STATE OF MAINE
DEPARTMENT OF TRANSPORTATION
☐ Approved
☐ Returned for Corrections
AUG 2[illegible] 1997
☒ Approved as noted
☐ Rejected

PROJ. NO. : BH-043-1(34)
ITEM NO. : 520.22

PROJECT: JOSHUA CHAMBERLAIN BRIDGE OVER THE PENOBSCOT RIVER, BANGOR-BREWER, ME

EXPANSION JOINT DETAIL @ PIER 1

PROJECT: JOSHUA CHAMBERLAIN BRIDGE OVER THE PENOBSCOT RIVER, BANGOR-BREWER, ME
SCALE: ~
DATE: 6/97
APPROVED BY:
DRAWN BY: BB
CHKD BY:
SIDEWALK DAM DETAIL @ PIER 1
REED & REED
JOB NO. 97-49
DWG. NO. 5

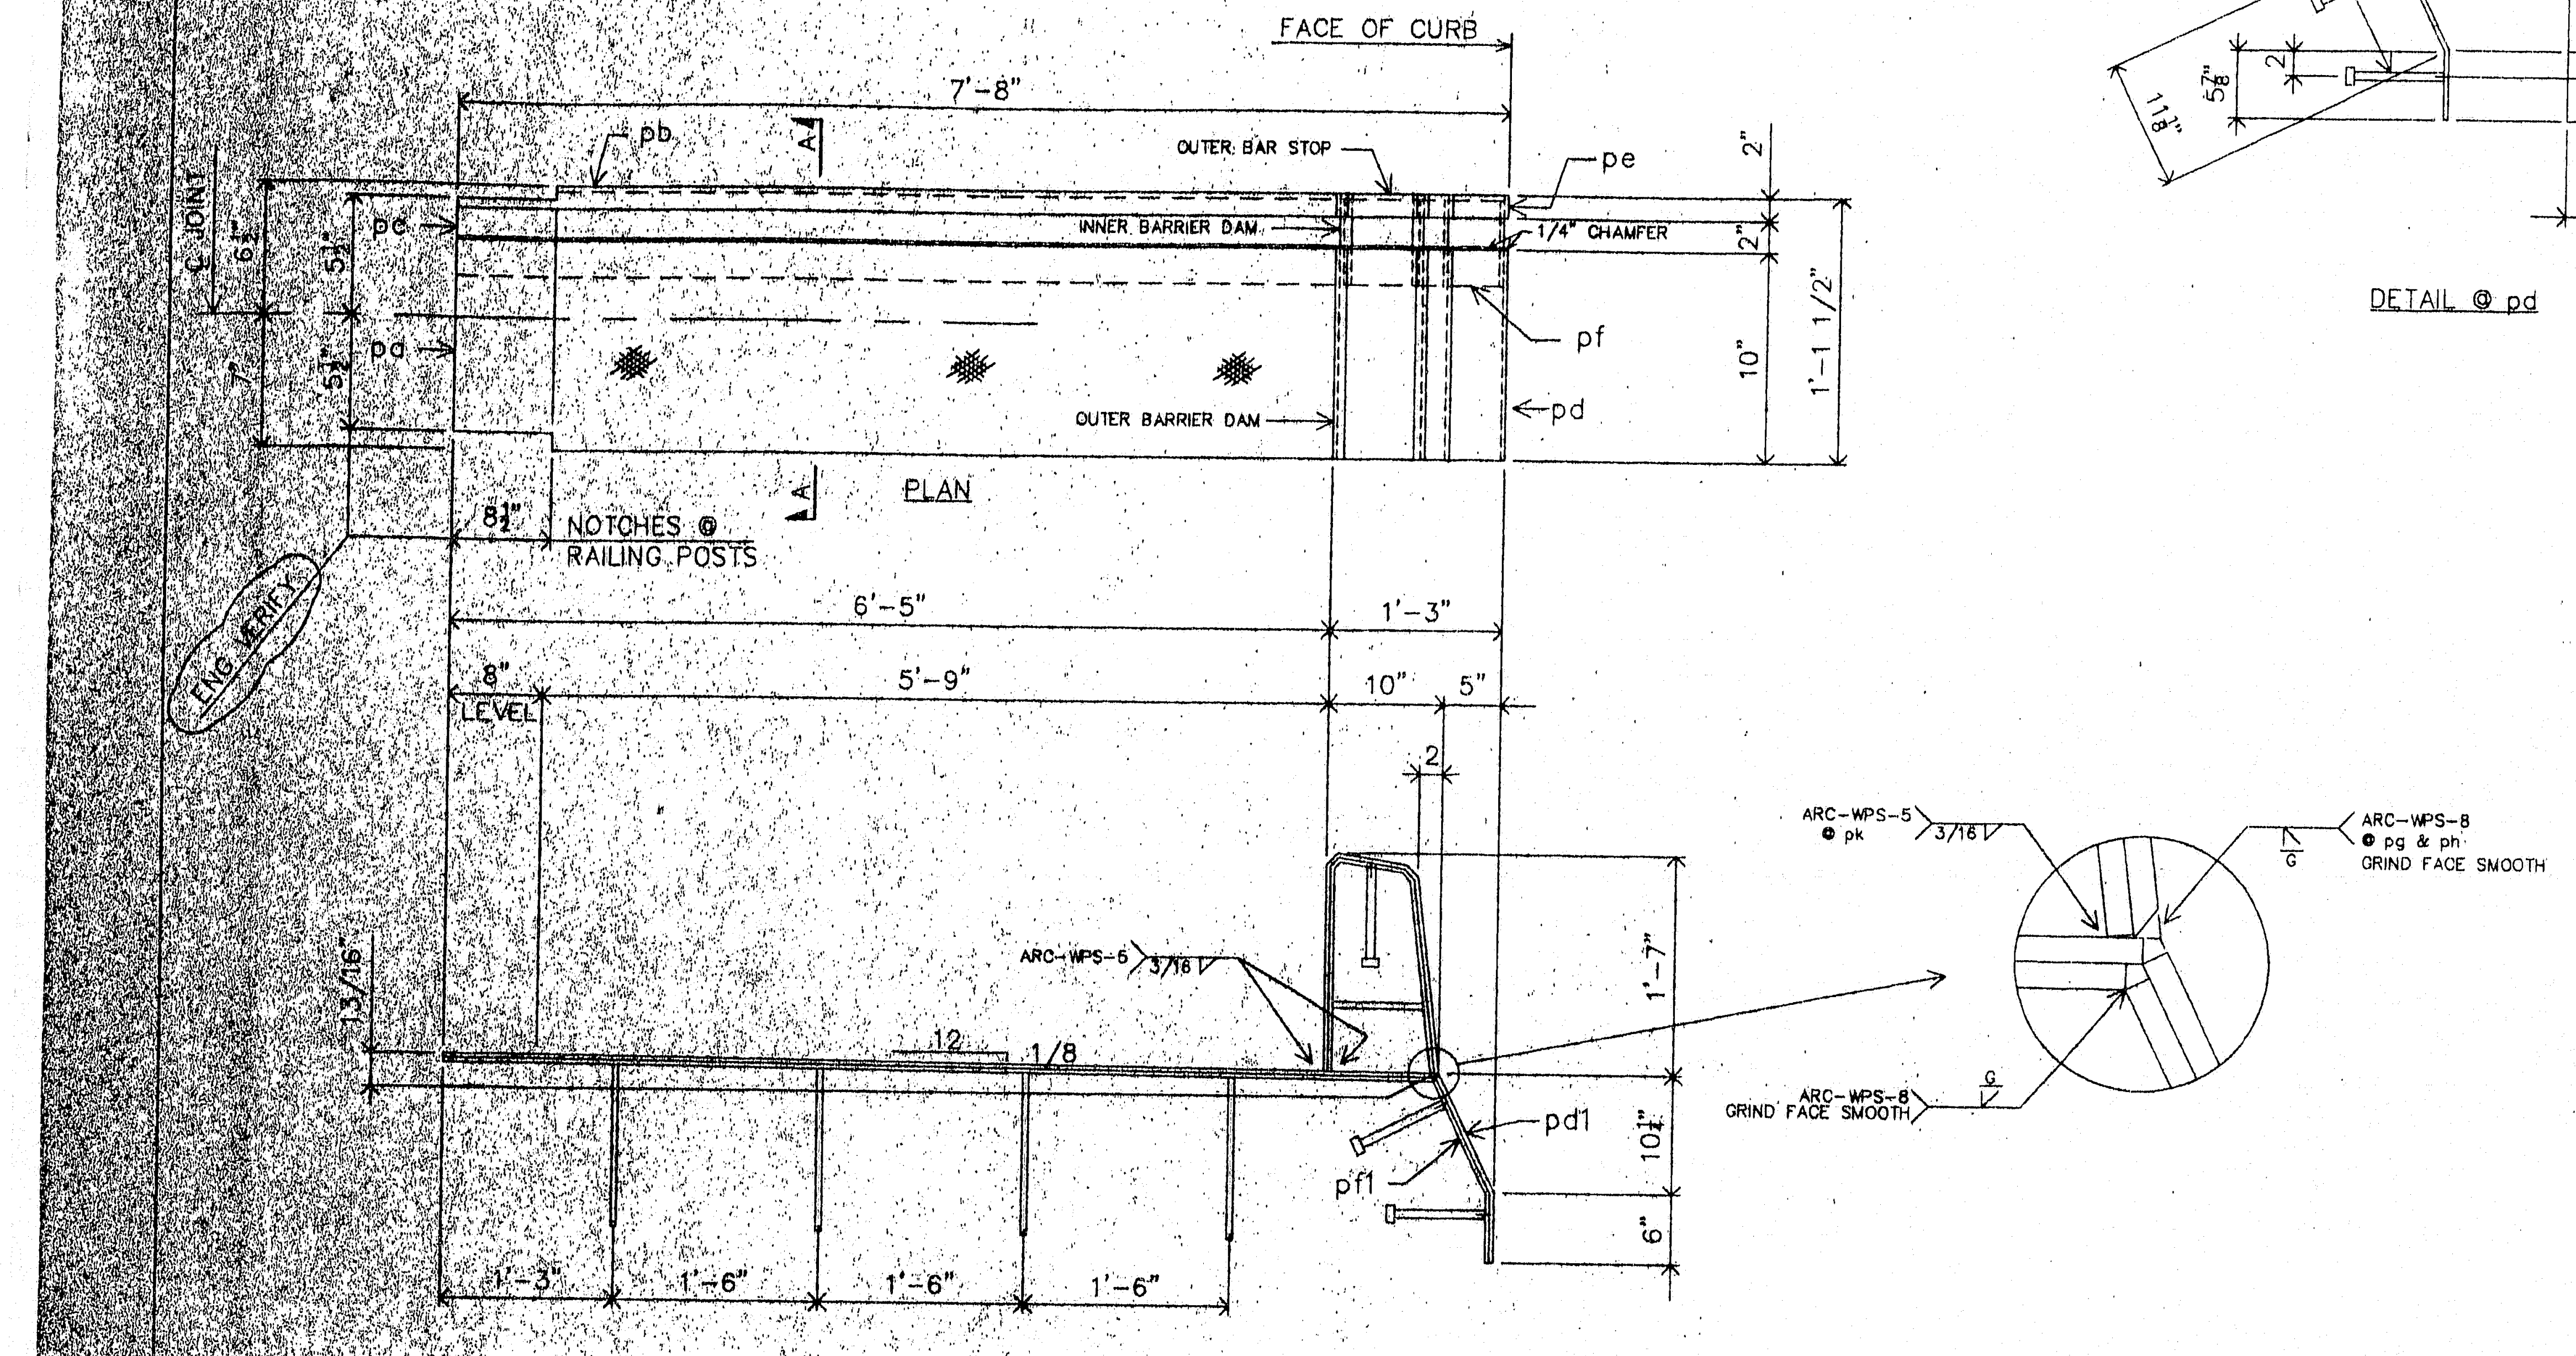
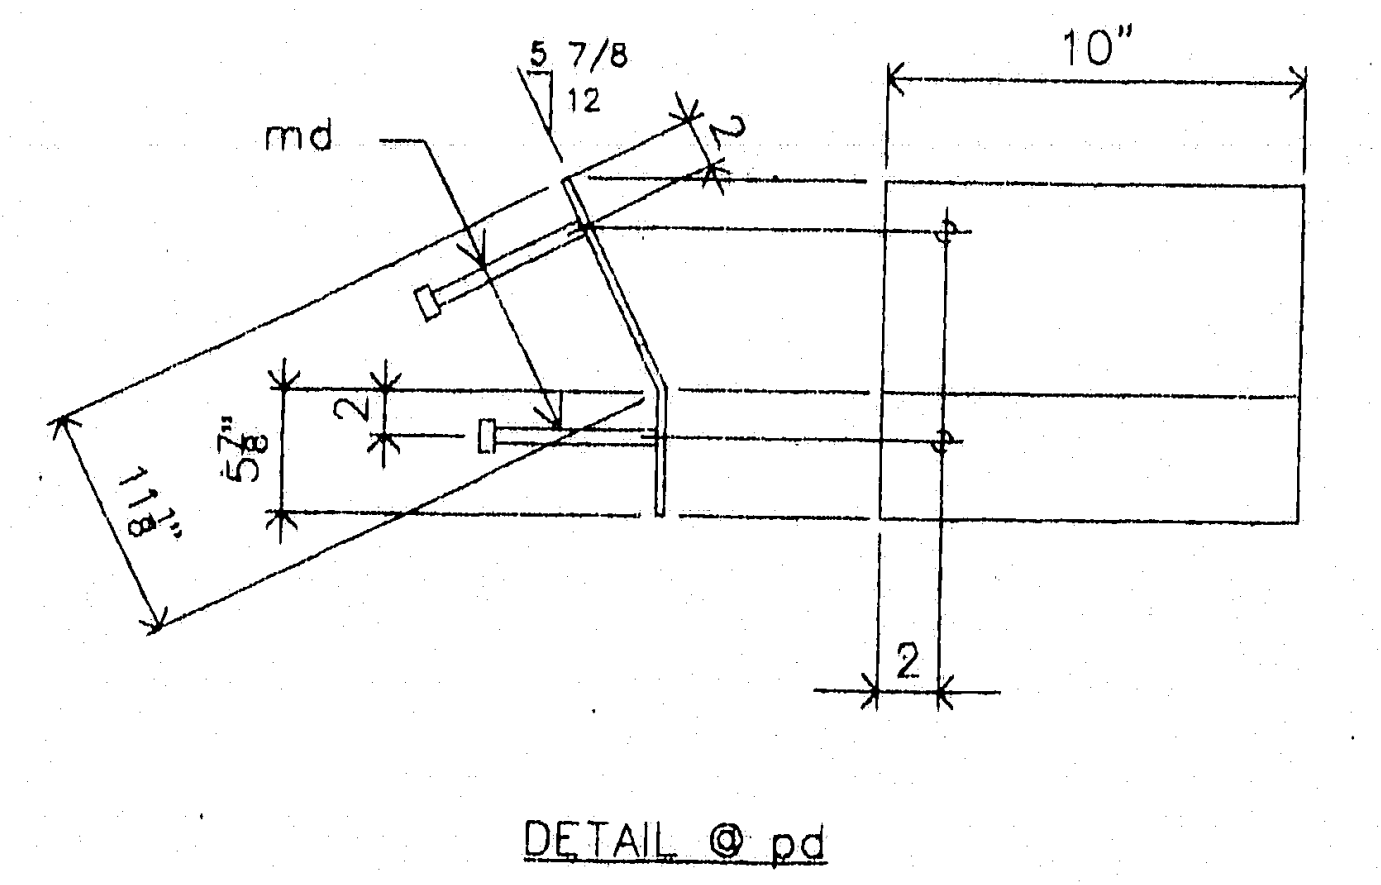
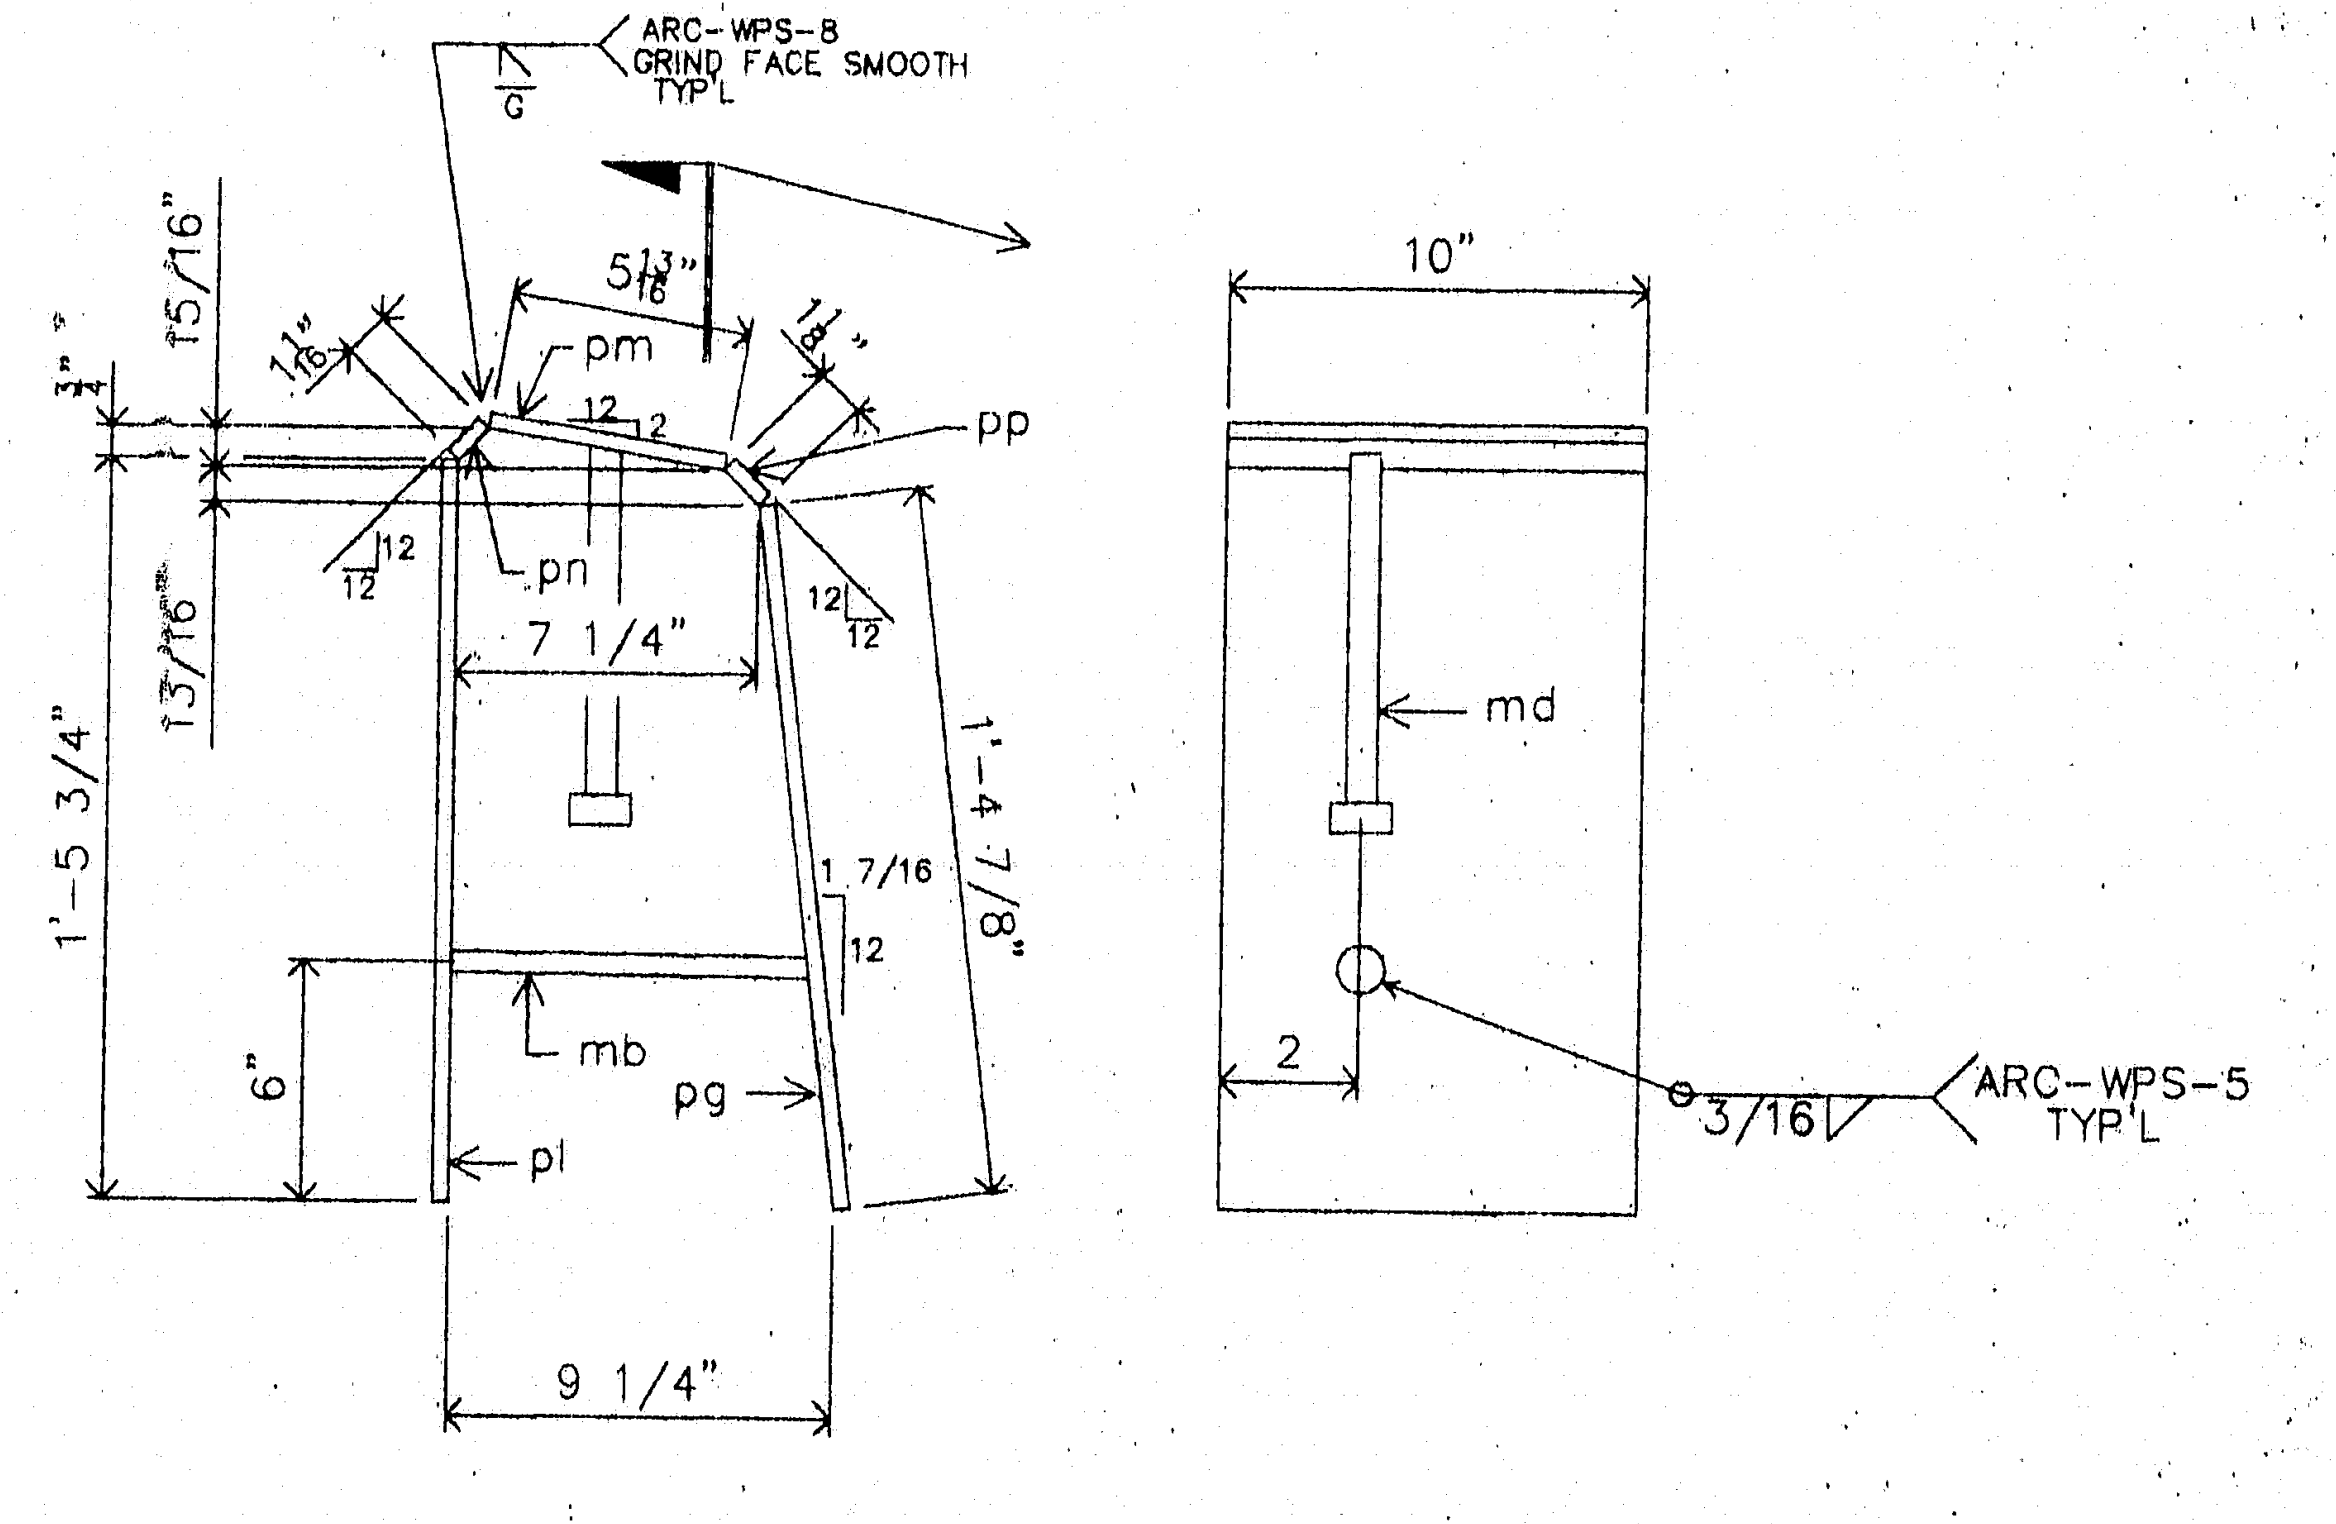
MATL: A36 UN HOLES: AS NOTED
WELD: PER PROCEDURES NOTED
PREP: SP6
FINISH: ~~3 COATS ZINC RICH PRIMER~~
~~3 MDFT PER COAT~~

* Prefer - Get Price on Galvanizing Assembly.

or
Use different Paint System.
Use NepCoat List;
Typical Systems:
Carboline
Wasser
Keeler & Long
Should Use
1) Zinc Rich Primer
2) 2 Part epoxy
3) Urethane.
